GENERIC DESIGN ASSESSMENT – NEW CIVIL REACTOR BUILD

**STEP 3 CIVIL ENGINEERING AND EXTERNAL HAZARDS ASSESSMENT OF THE
EDF AND AREVA UK EPR**

DIVISION 6 ASSESSMENT REPORT NO. AR 09/039-P

Map Showing Finite Element Code Coverage in the UK EPR Design

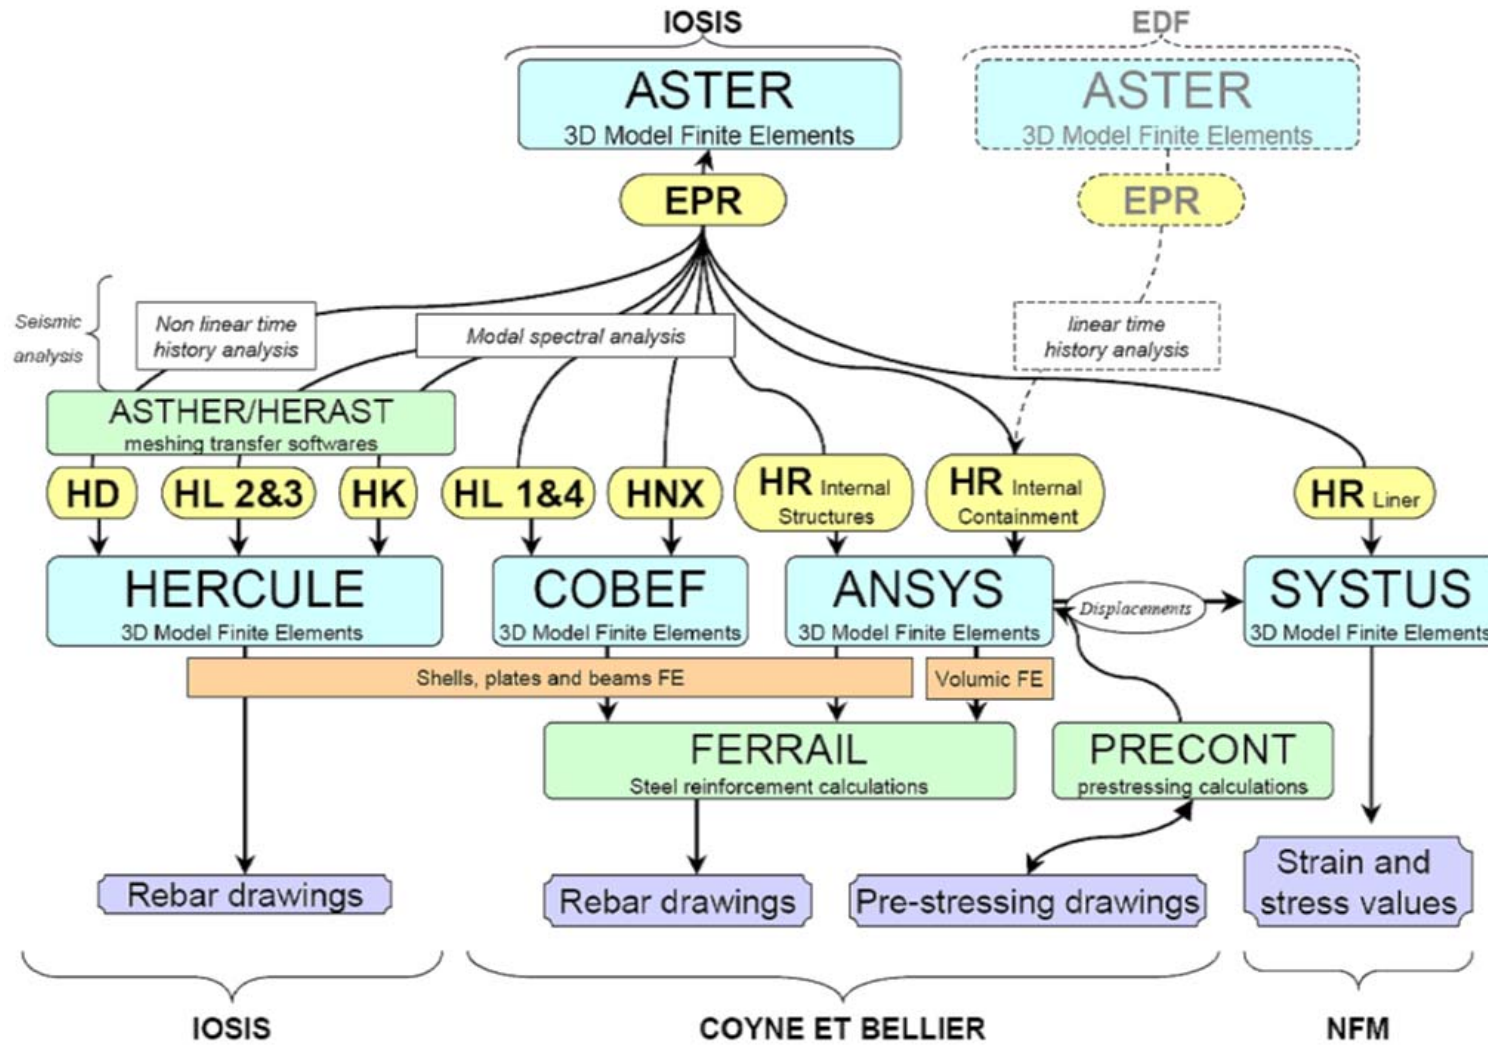
186 A wide range of Finite Element Codes and related software has been used in the UK EPR design. Figure 2 provides an overview of the most important codes used. The initial phases of Step 3 have focussed on understanding the codes used, and their interrelationship. The sections below summarise the types of code used and their applicability in the design. Following the basic code descriptions, the intended strategy for the assessment of the codes across Step 3 and Step 4 is presented. Following that is a summary of progress to date. It is unfortunate that progress has not been as far as wished. The key reasons for this are the extended time taken to receive documents from EDF and AREVA and the time taken for translation of key documents. It should be noted that there are often extensive document libraries associated with each of the codes. For example, Code ASTER has almost 2000 documents associated with it. As part of the assessment we have focussed on a smaller subset of these (20-30) documents which are central to the operation of the code, and its verification and validation.

Figure 5: Principal Data Sources - Combinations

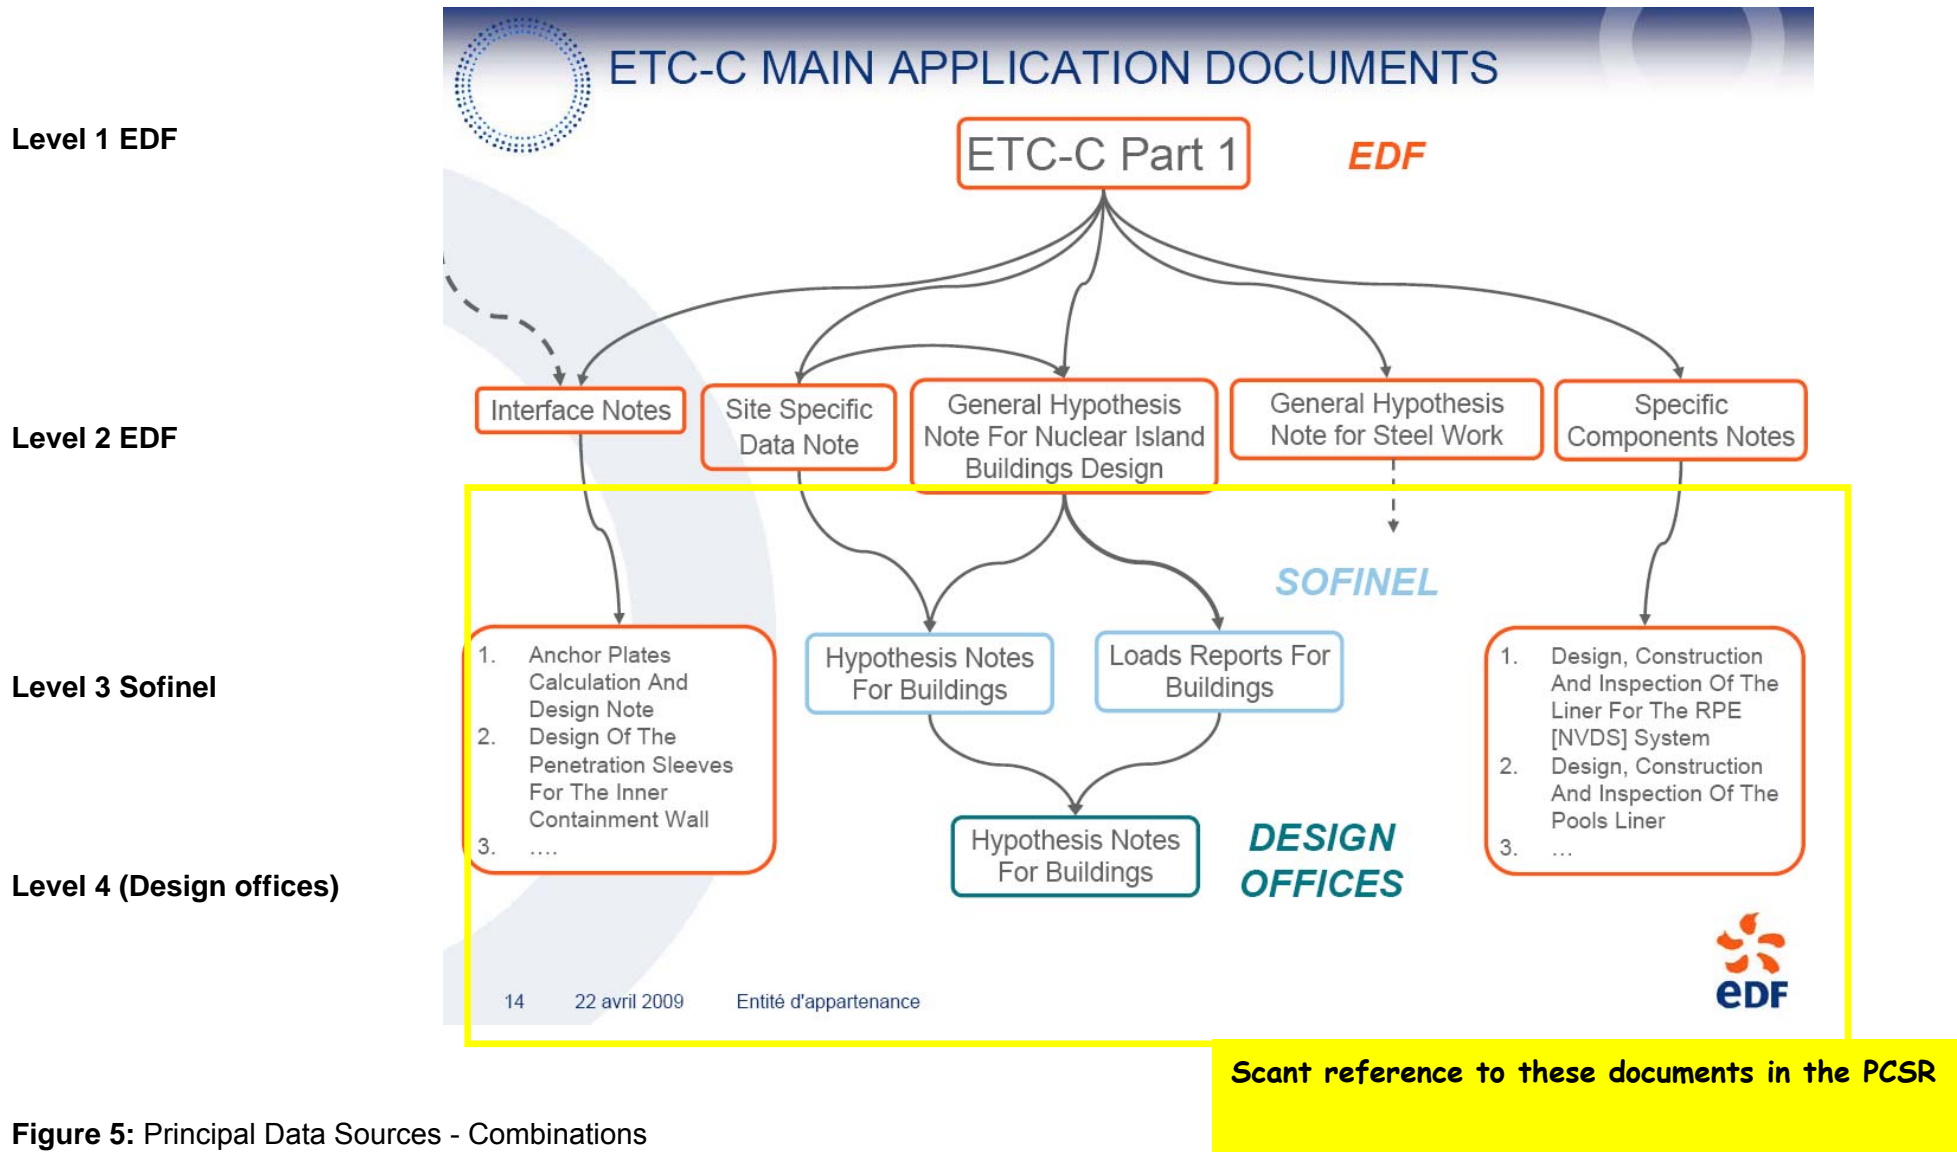
- 117 Figure 5 shows the 4 levels of documents which have been identified through the work undertaken thus far. The review of these hypothesis documents is ongoing, however several key points have become apparent already.

- 118 Screening of hazards at a detailed level is undertaken and detailed at the lowest level of hypothesis document. An example is the lack of need to consider wind loading for the inner containment structure as it is shielded by the aircraft shell, other than during construction. This can be seen to be a sensible approach, however it is surprising that such a principle were not established at a higher level within the documentation. It leaves open the question of whether decisions taken at a lower level in the process are consistent with the principles laid down in the PCSR. This is perhaps a reflection of the timing of the production of the various documents which detail the EPR design approach.
